Paper No. 6224

Water supply for the Yeovil district (Sutton Bingham scheme)†

Discussion

FIG. 19.—CALIBRATION OF OVERFLOW WEIR WITH CIRCULAR OUTLET TUNNEL.
MODEL VALUES

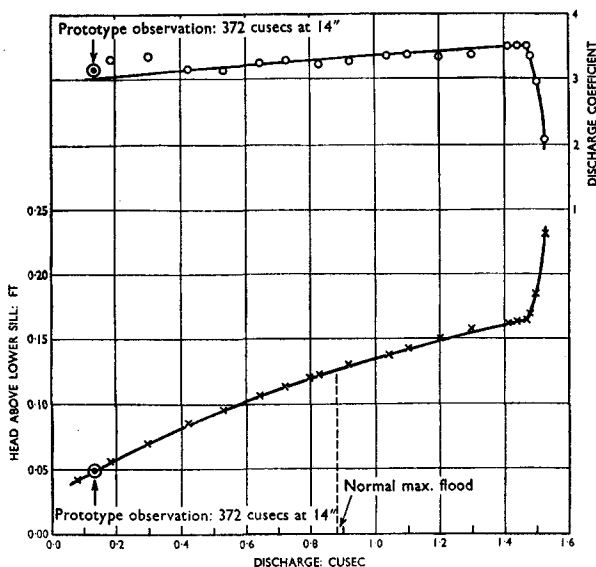
Mr L. E. Prosser (The British Hydromechanics Research Association) was particularly interested in the full-scale confirmation of the model tests for predicting the capacity of the spillway. Fig. 19 showed the model results and the confirmatory point obtained from the 14-in. flood-level observation. The determination of the exact values of the coefficient of discharge might seem a rather trivial academic point, but Fig. 20 showed that it had considerable economic significance.

235. The 22-in. discharge over the weir, which was the largest yet recorded, was equivalent, so far as could be assessed from the model chart, to about 1,000 cusecs. The flood had occurred after a very severe storm centred over Weymouth, where a rainfall of about 7 in. had been recorded in 24 hours. Speaking from memory, the rainfall on the catchment area had been about half of that over the same period; so that a rainfall of about $3\frac{1}{2}$ in. or possibly a little more in 24 hours had produced the flood of 1,000 cusecs.

FIG. 20.—COMPARISON OF SPILLWAY PROFILES WITH THE WAGNER WEIR PROFILE

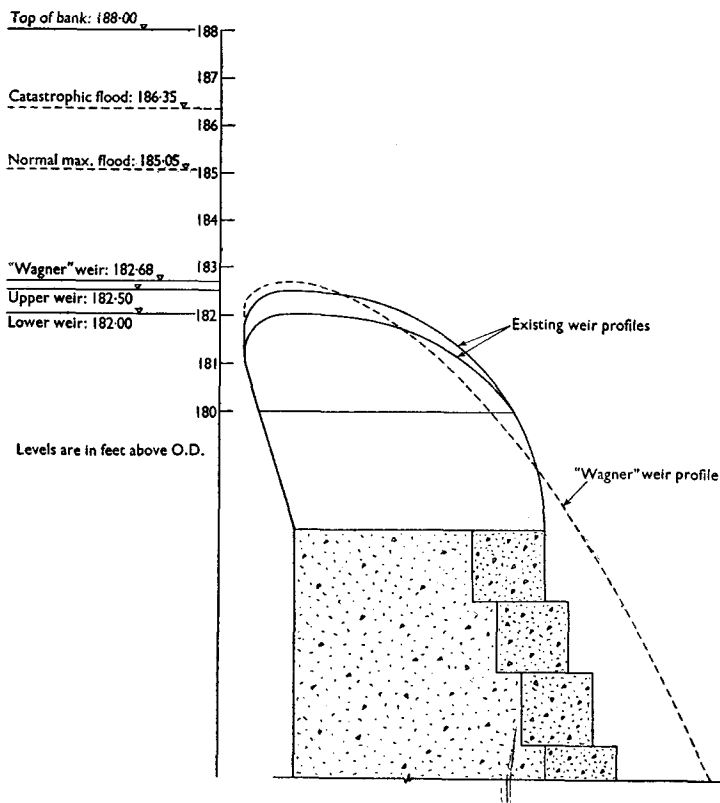
171. In Fig. 20 the profile of the spillway was shown by heavy black lines; there were two curves because the crest level of a portion of the weir had been lowered 6 inches to localize the discharge. Flood levels for normal and catastrophic floods were indicated and after allowing something extra for waves there was a total freeboard of about 6 ft.

172. The engineering design was undoubtedly sound but was this also true of the underlying philosophy? Absolute fool-proof safety had been provided at the expense of building a reservoir high enough and strong enough to hold about 800,000,000 gal of water but which in practice contained only 575,000,000 gal. Anything which would reduce the ullage of about 200,000,000 gal of air was worth serious study.

173. From the point of view of the conventional spillway it was possible to make small gains. The second profile in Fig. 20 was based on work published recently by Wagner⁸ which would enable the top water level to be raised about 2 in. for the same

230. Replying to Mr Prosser, the Authors said that they had been very interested in trying to tie up the actual flow discharge of the weir with the diagram from the model tests. This was always difficult because of wave action. It was difficult to find a period when the water level was so still that it was not influencing the discharge. On the Birmingham reservoirs, for example, wave action could cause a discharge of about 100 m.g.d. The Authors had been fortunate in getting one or two readings, but they could not get any of the very high flows because the measuring weir downstream was used as a check and the flume quickly became drowned owing to the choking of the river channel on ground further downstream and outside the control of the local authority.
